REMARKS/ARGUMENTS

II. Drawings

FIG. 1 (PRIOR ART)

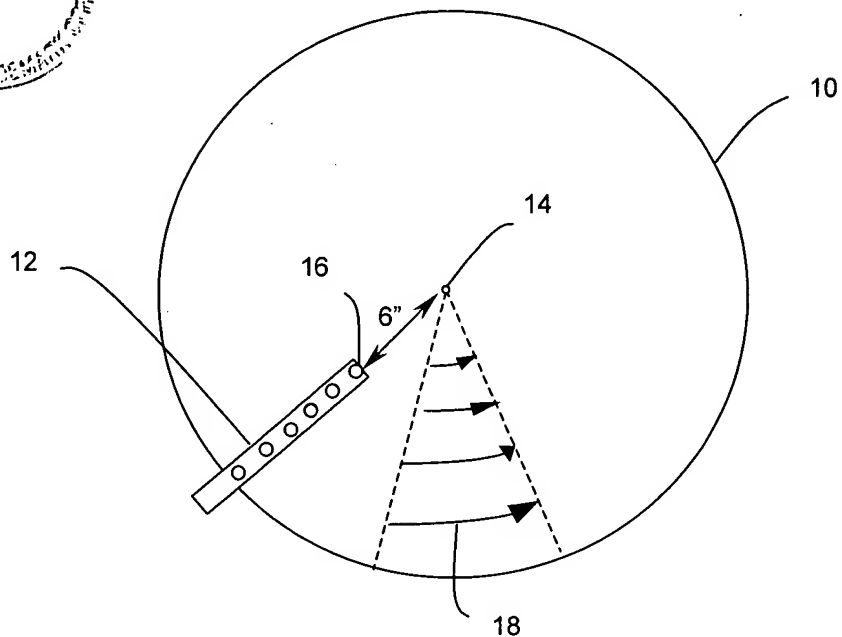
In the subject Office Action, the Examiner objected to FIGS. 1 and 2 not being labeled as being prior art. As shown in the Annotated Sheets for FIGS. 1 and 2, the Replacement Sheets for FIGS. 1 and 2 now include the label "PRIOR ART".

FIG. 3

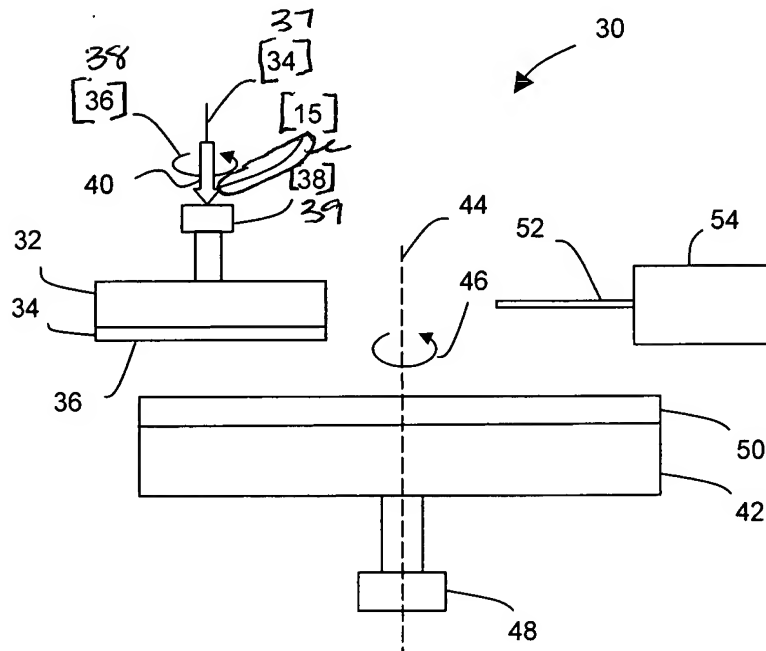
In FIG. 3, the Examiner objected to the use of reference character "34" for both the wafer and the axis. The axis has been relabeled with a reference character 37. The Examiner objected to the use of reference character "36" for both the surface and the arrow. The arrow has been relabeled with a reference character 38. The "motor 38" has been relabeled as "motor 39". Additionally, reference character "15" was removed. Annotated sheets showing changes and replacement sheets are attached to the end of this response.

Due to the changes to the drawings described above, in paragraph 0018, the "axis 34" has been changed to "axis 37", the "arrow 36" has been changed to "arrow 37" and the "motor 38" has been changed to the "motor 39".
